62 WOLSELEY ROAD, LONDON, N8 8RP: ECO HOUSE SCHEME

NON-MATERIAL AMENDMENT APPLICATION

PLANNING STATEMENT
MARCH 2023

10. Proposed single storey master bedroom block with full height sliding door opening to the private rear garden. The opening light is approximately 30m from the nearest window of 2 and 4 Glasslyn Road.

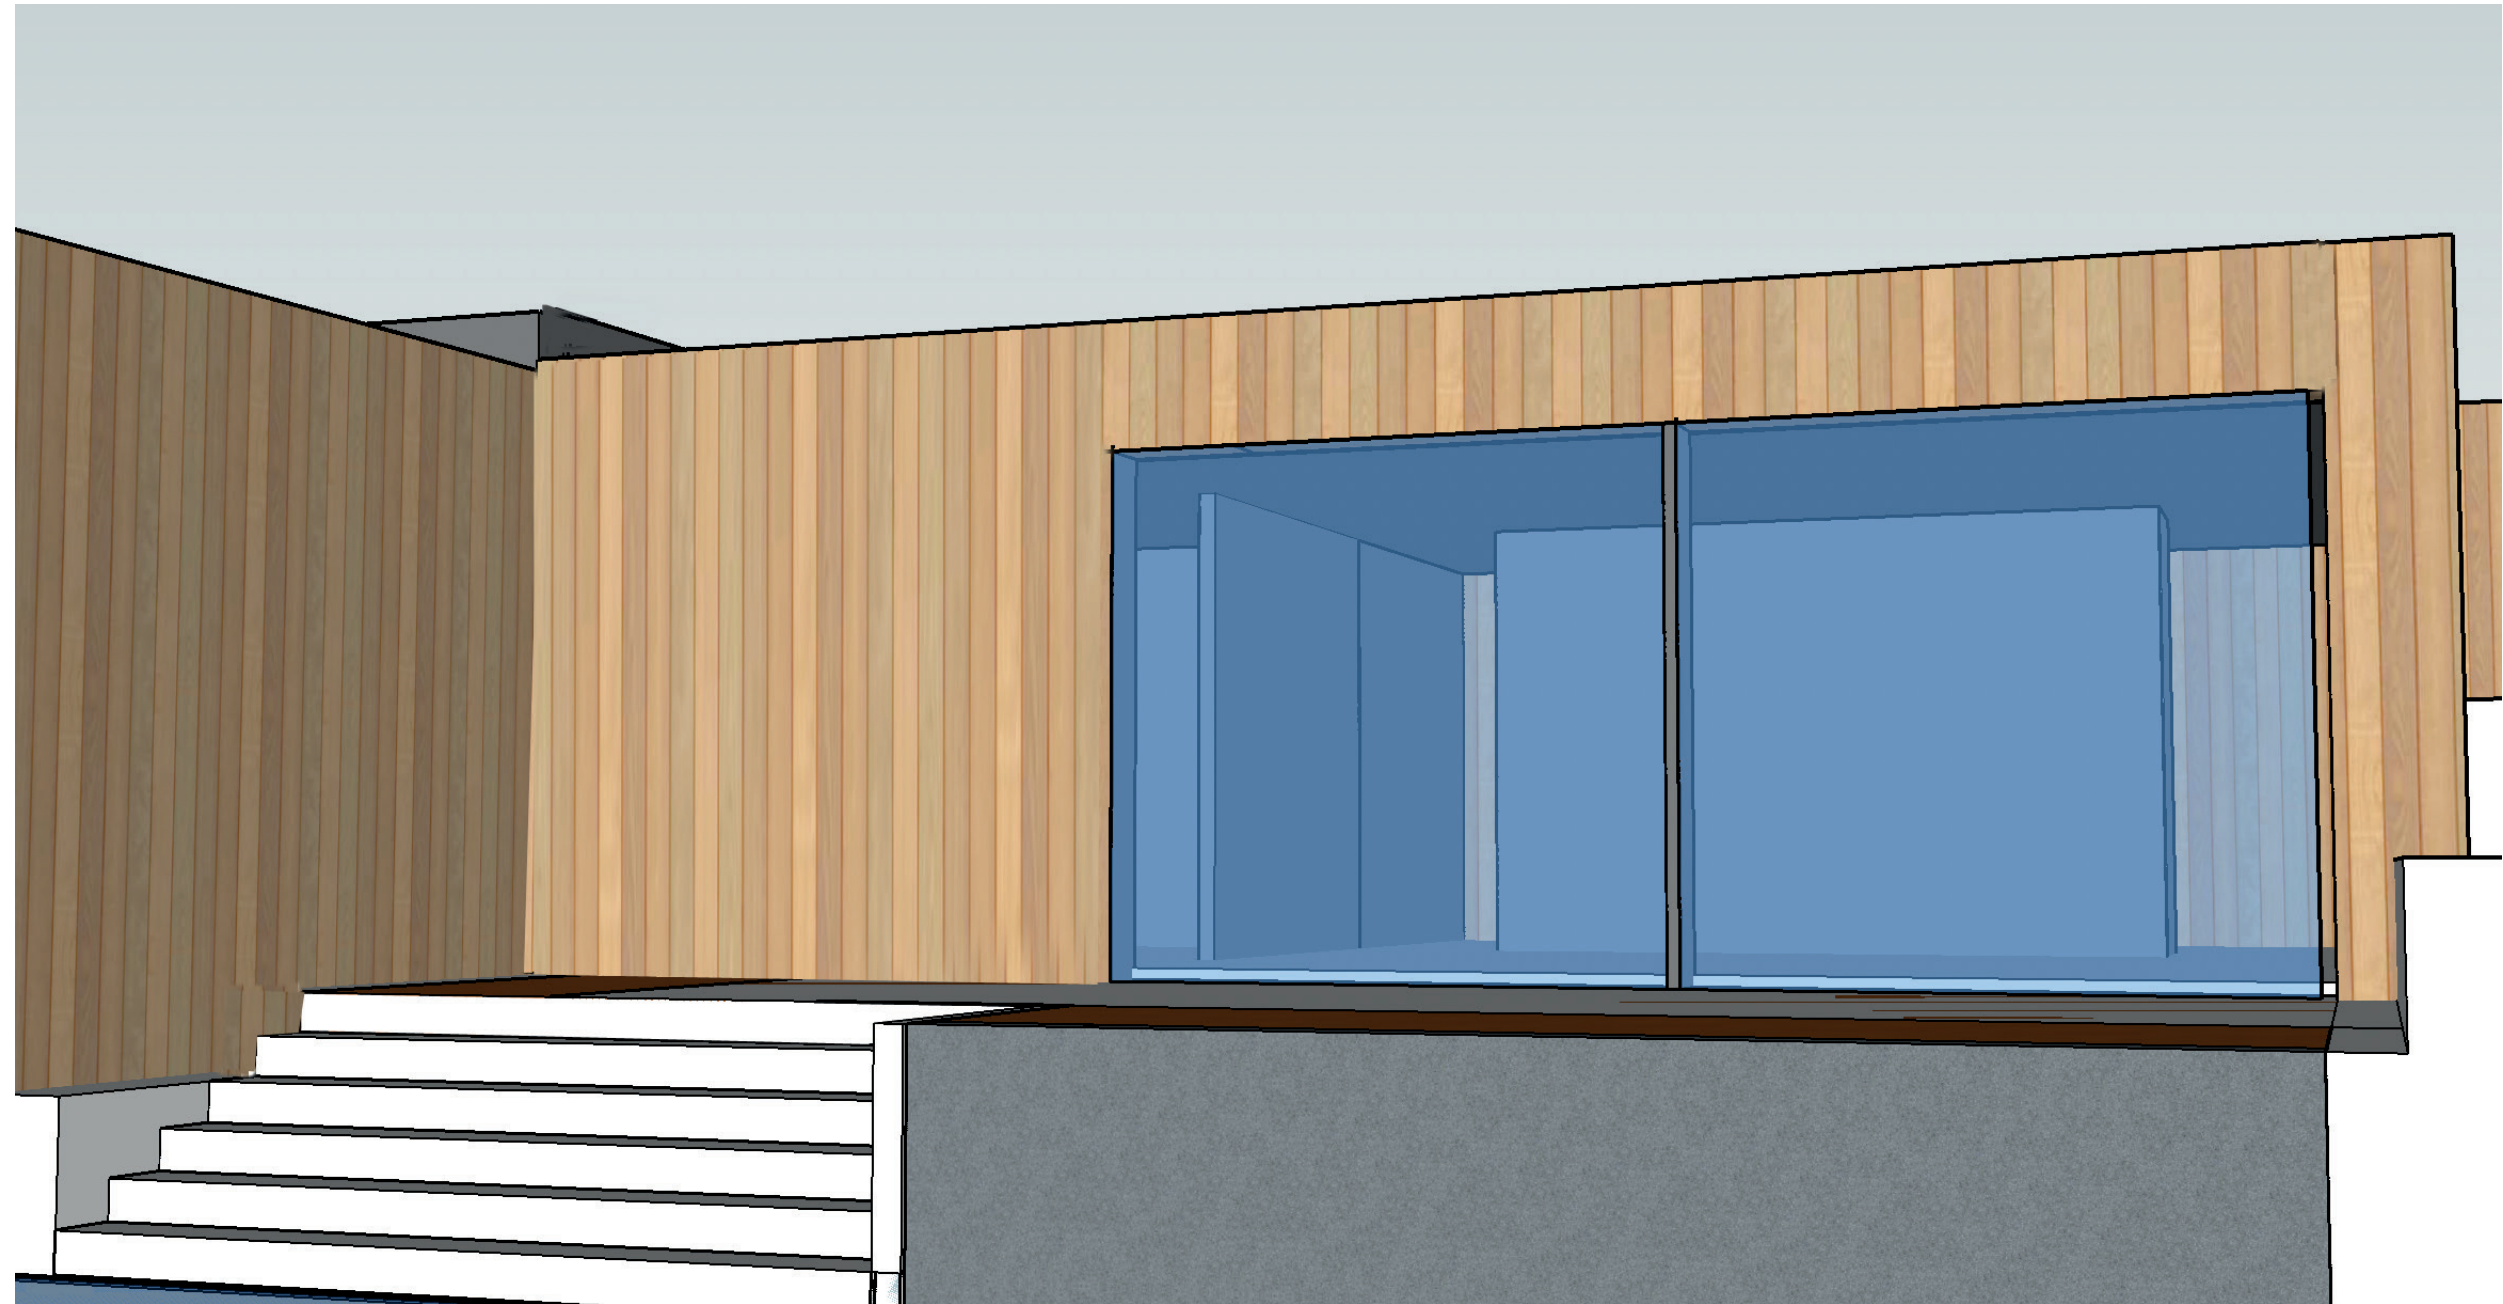
New single storey master bedroom block added

11. Proposed external wall (North-East Elevation) to be moved 700mm towards rear gardens of Tivoli Road.

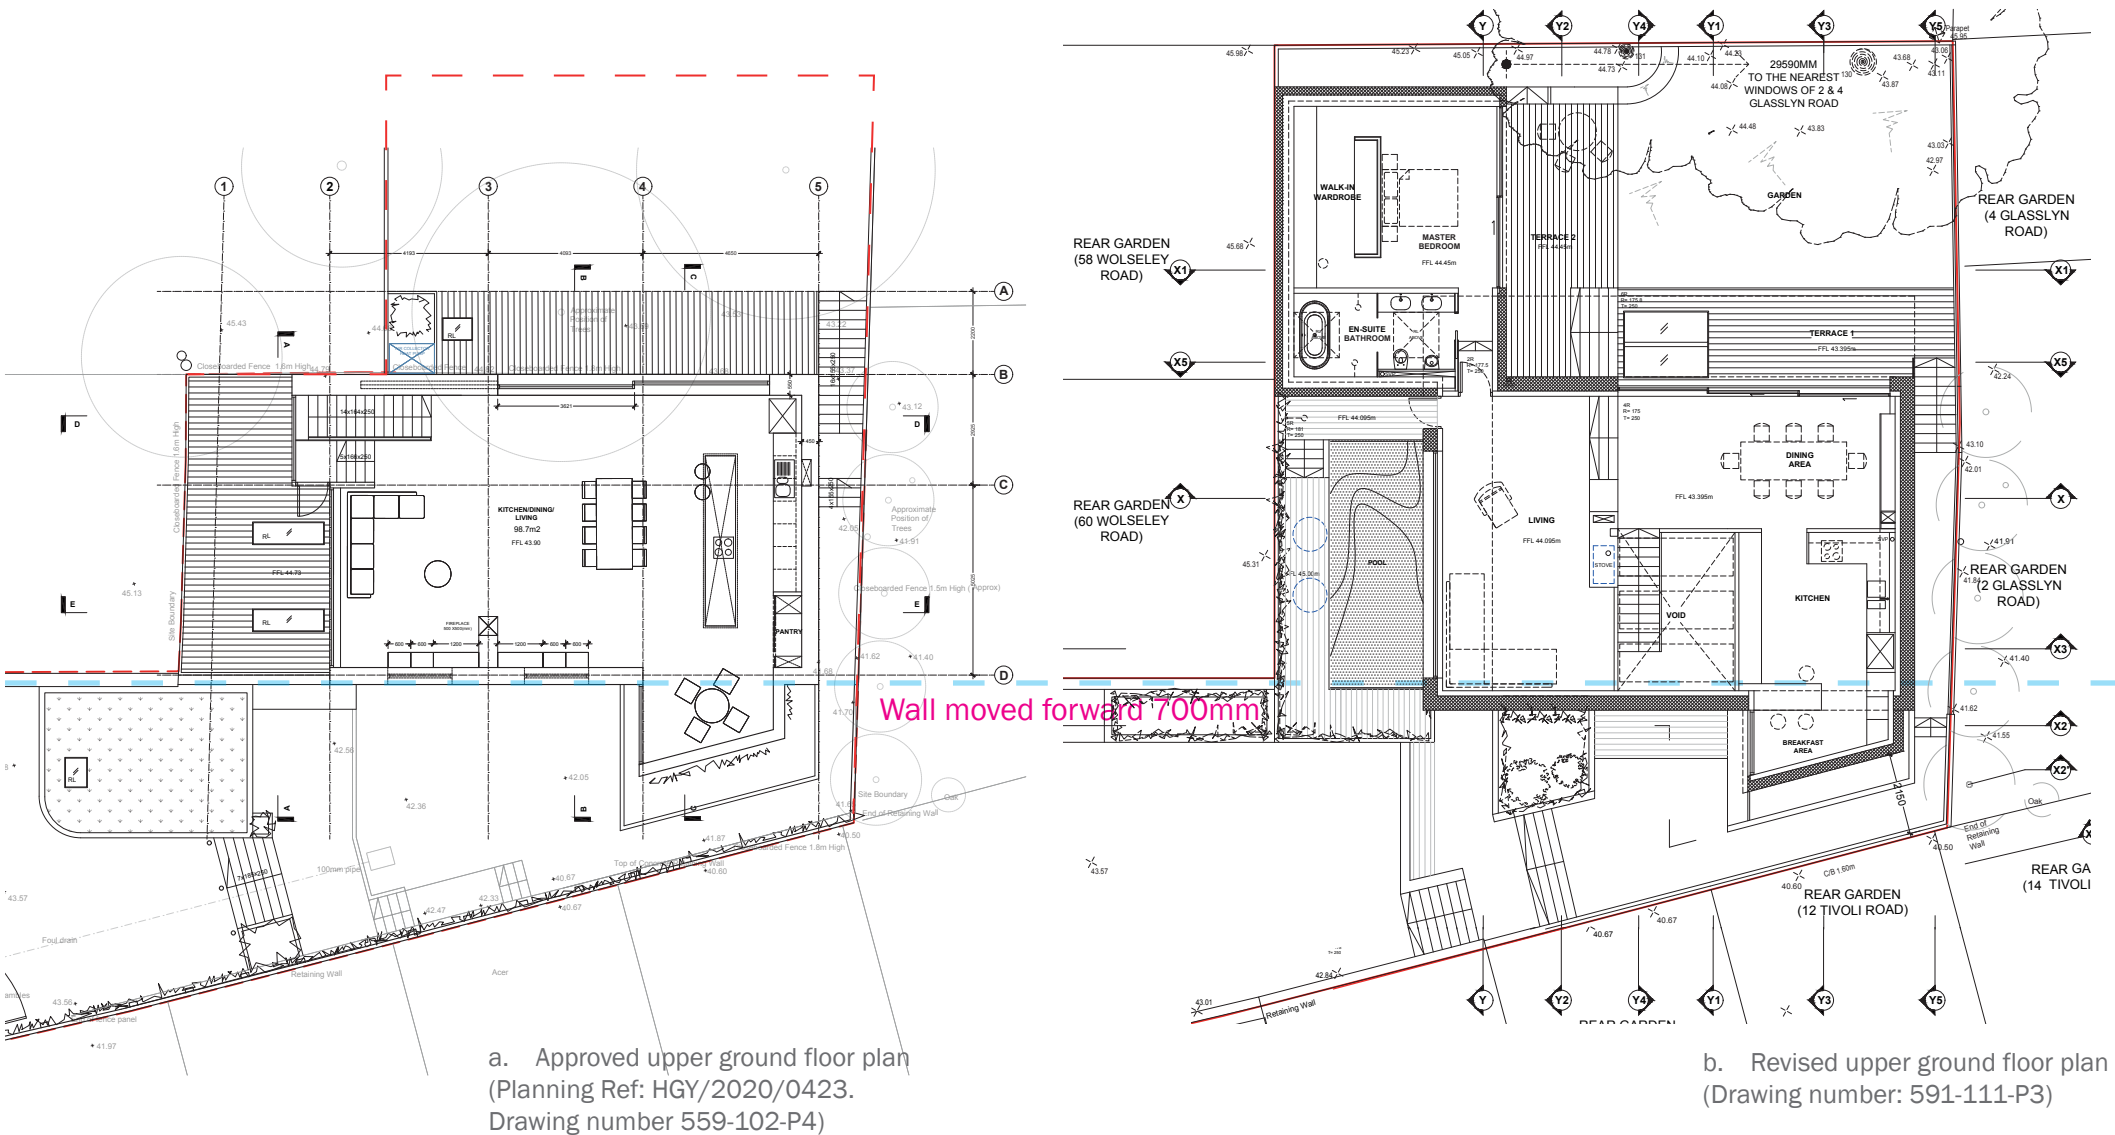
- 4.1. Facade: The north-east facing façade of the building is to be moved out by 700mm, remaining parallel to the original building line. The building remains more than 6000 mm on average, and more than 4500 mm at its nearest point, from the boundary with the neighbouring Tivoli Road gardens, with the buildings themselves set back another 14m from the boundary. This change therefore would have no impact on overlooking and negligible impact on shading.

14. 3D studies of the approved and revised North-East Elevation (Side elevation) (External wall facing rear gardens of Tivoli Road) with high level windows omitted.

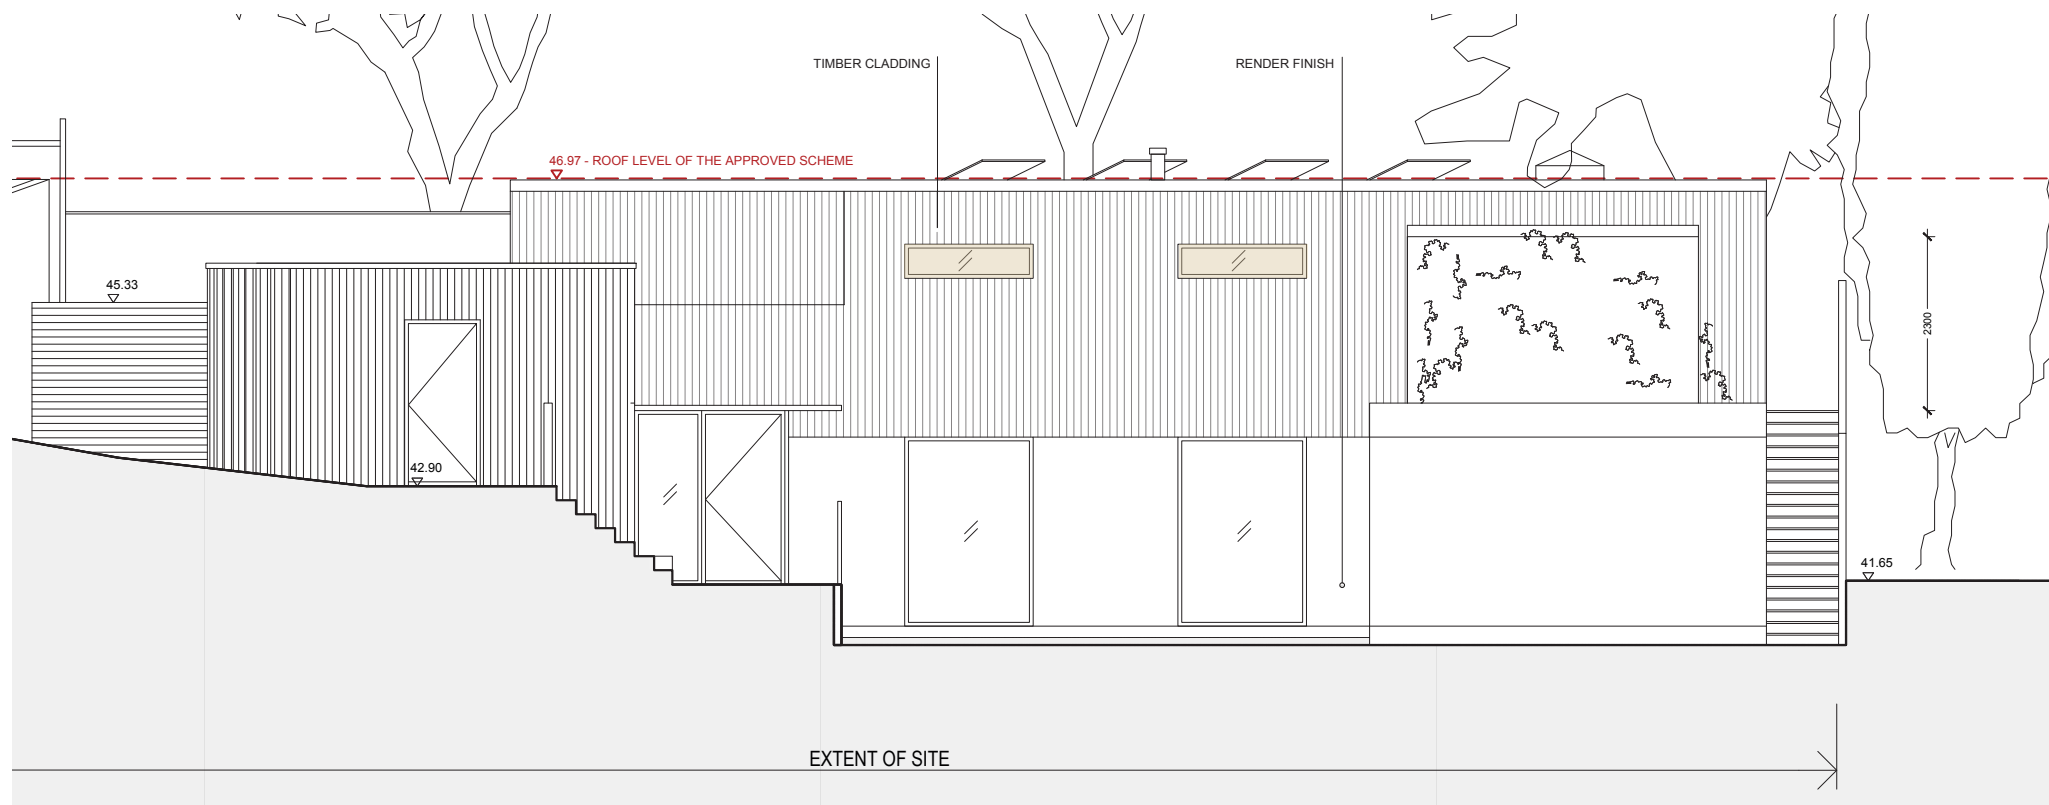
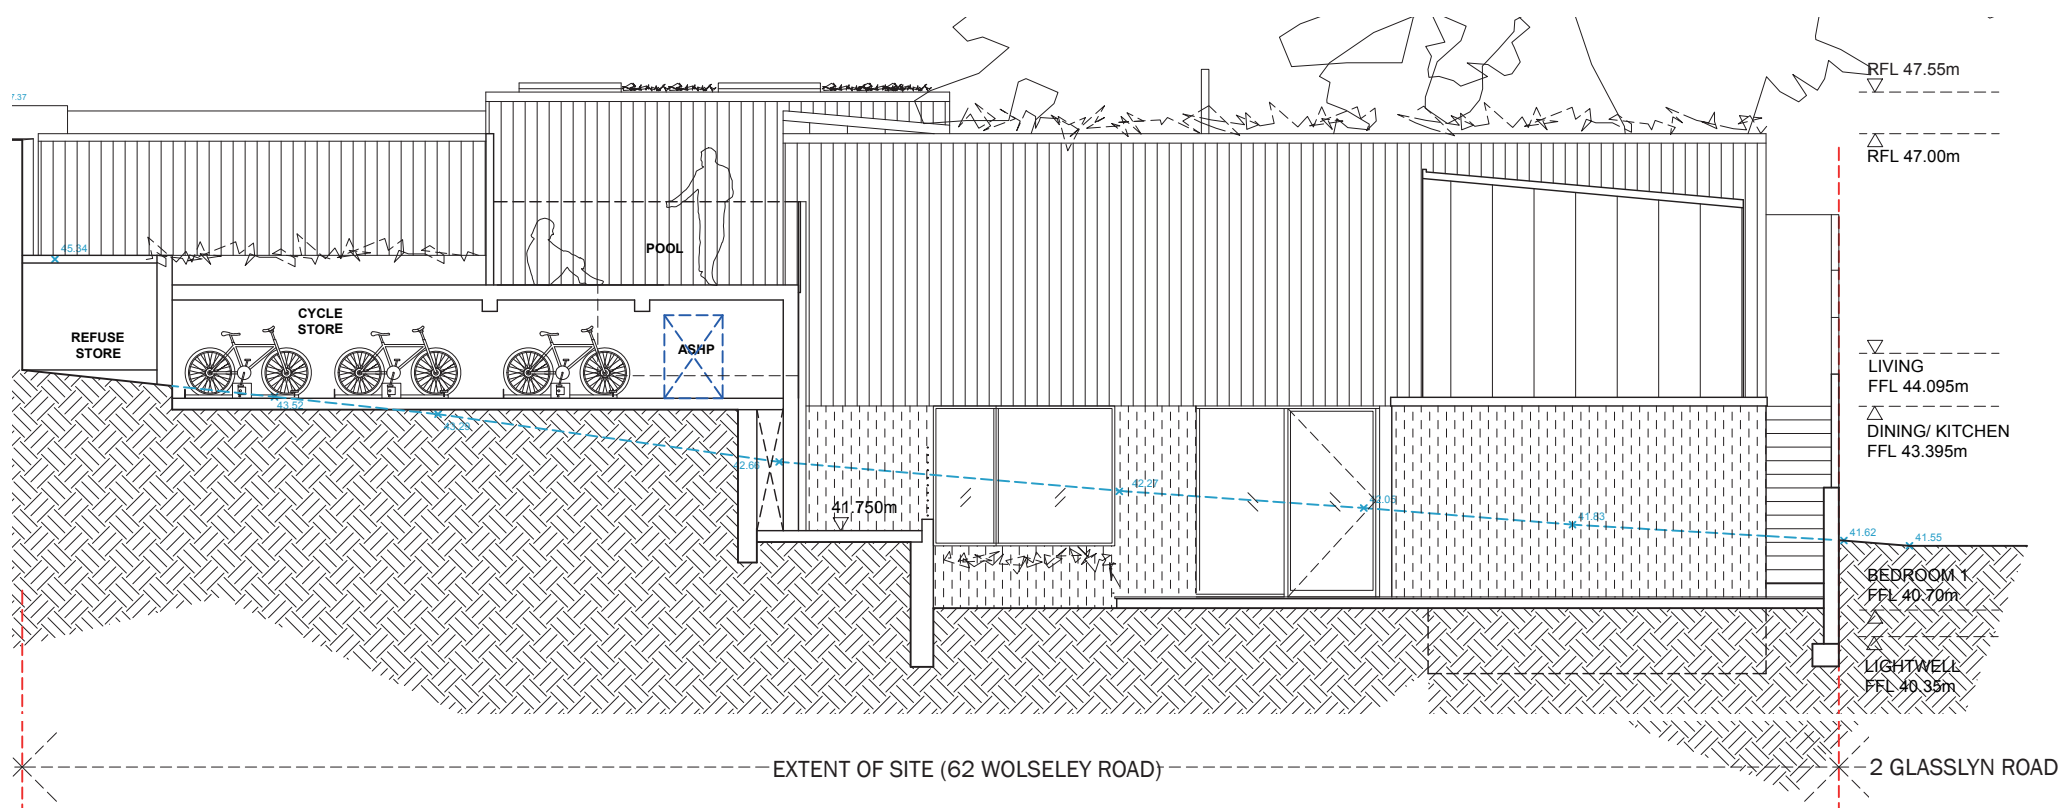
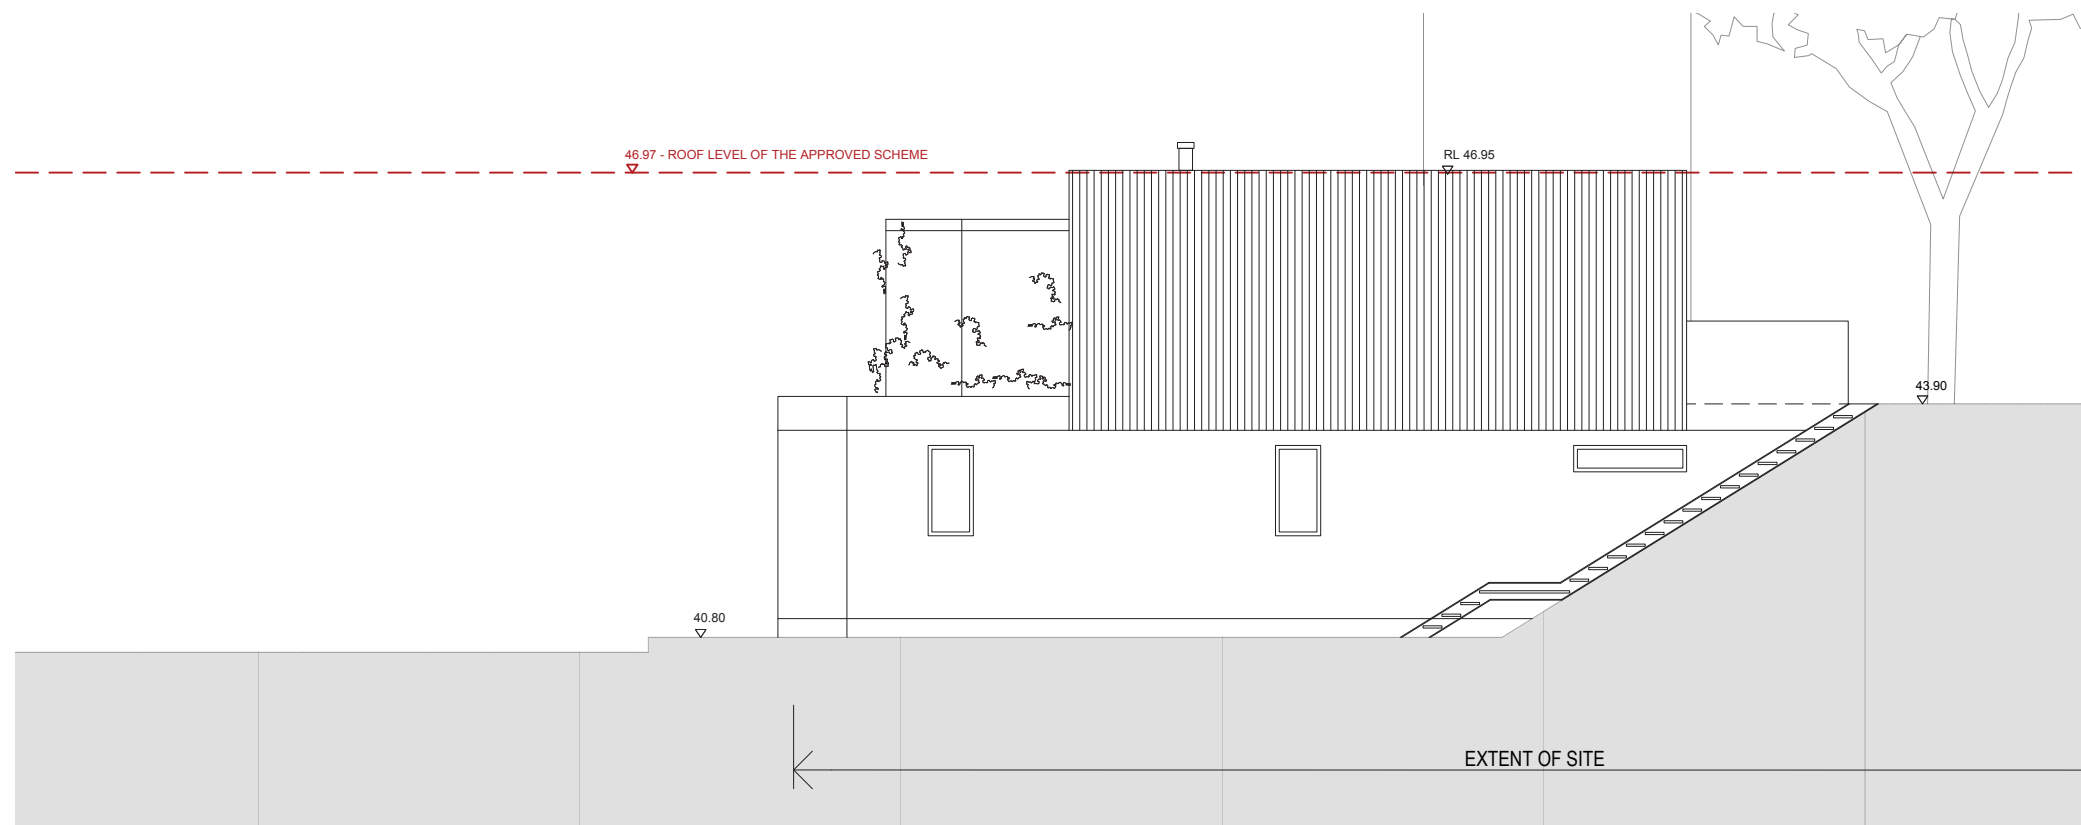
- 4.2. Lower Level Fenestration: There have been minor changes to windows on the lower level as a result of a change in the plan of the lower level, principally the relocation of the entrance to the centre of the plan. However, the fenestration is below the fence level facing towards Tivoli Road, and the change is therefore non-material.

- 4.3. Upper Level Fenestration: The windows on the upper level have been removed completely, thereby removing any possibility of light pollution from the building impacting the adjacent neighbours at Tivoli Road. (Refer to fig. 12, 13 & 14a & b)
